PLAT COMMITTEE

March 14, 2024

Case Number:	2024-PLT-003
Property Address:	2060 Yandes Street (Approximate Address)
Location:	Center Township, Council District #13
Petitioner:	Donna S. Cunningham, Trustee of the Donna S. Cunningham Living Trust, by Leslie Steinert
Zoning:	D-P
Request:	Approval of a Subdivision Plat to be known as Monon 21, subdividing 3.44 acres into 54 lots and four blocks.
Waiver Requested:	None
Current Land Use:	Vacant industrial
Staff Reviewer:	Linda Ahlbrand, Principal Planner II

MONON 21 SUBDIVISION
A REPLAT OF LOTS 13, 14, 15, 18 AND 17 IN BLOCK 18 AND LOTS 10, 11, 12, 13,
14, 15, 16, 17, 18, 19, 20, 21, 22, 23, 24, 25 IN BLOCK 19 IN SA. FLETCHERS JR.'S
NORTHEAST ADDITION TO THE CITY OF INDIANAPOLIS.

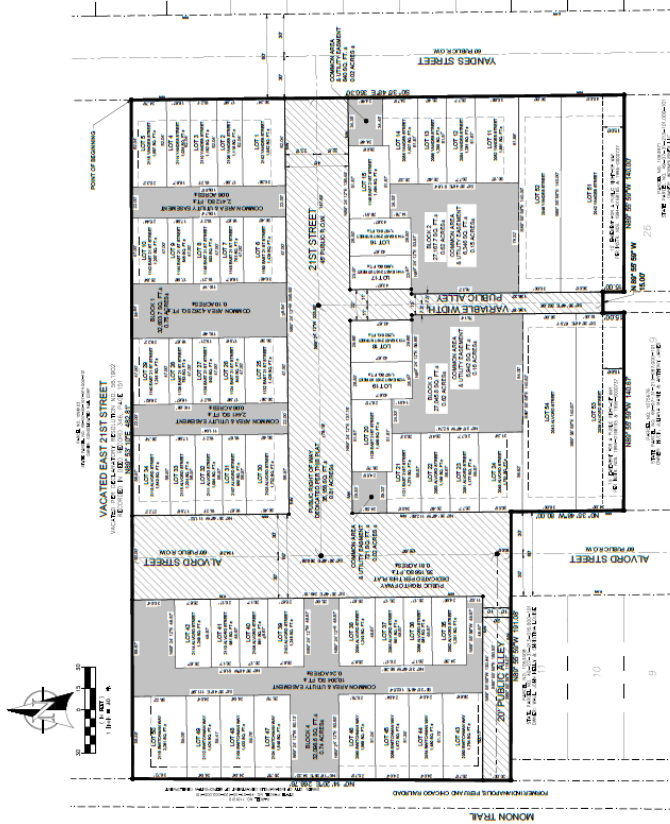
Staff recommends that the Plat Committee **approve** and find that the plat, file-dated January 22, 2024, complies with the standards of the Subdivision regulations, subject to the following conditions:

1. That the applicant provides a bond, as required by Section 741-210, of the Consolidated Zoning and Subdivision Ordinance.
2. Subject to the Standards and Specifications of Citizens Energy Group, Sanitation Section.

3. Subject to the Standards and Specifications of the Department of Public Works, Drainage Section.
4. Subject to the Standards and Specifications of the Department of Public Works, Transportation Section.

5. That addresses and street names, as approved by the Department of Metropolitan Development, be affixed to the final plat prior to recording.
6. That the Enforcement Covenant (Section 741-701, of the Consolidated Zoning and Subdivision Ordinance) be affixed to the final plat prior to recording

7. That the Site Distance Covenant (Section 741-702, of the Consolidated Zoning and Subdivision Ordinance) be affixed to the final plat prior to recording.

8. That the Sanitary Sewer Covenant (Section 741-704, of the Consolidated Zoning and Subdivision Ordinance) be affixed to the final plat prior to recording.

9. That the Storm Drainage Covenant (Section 741-703, of the Consolidated Zoning and Subdivision Ordinance) be affixed to the final plat prior to recording.
10. That the plat restrictions and covenants, done in accordance with the rezoning commitments, be submitted prior to recording the final plat.
11. That all the standards related to secondary plat approval listed in Sections 741-207 and 741-208 of the Consolidated Zoning and Subdivision Ordinance be met prior to recording the final plat.
12. That a Topographic Map and a Traffic Control Plan, be submitted prior to recording the final plat.
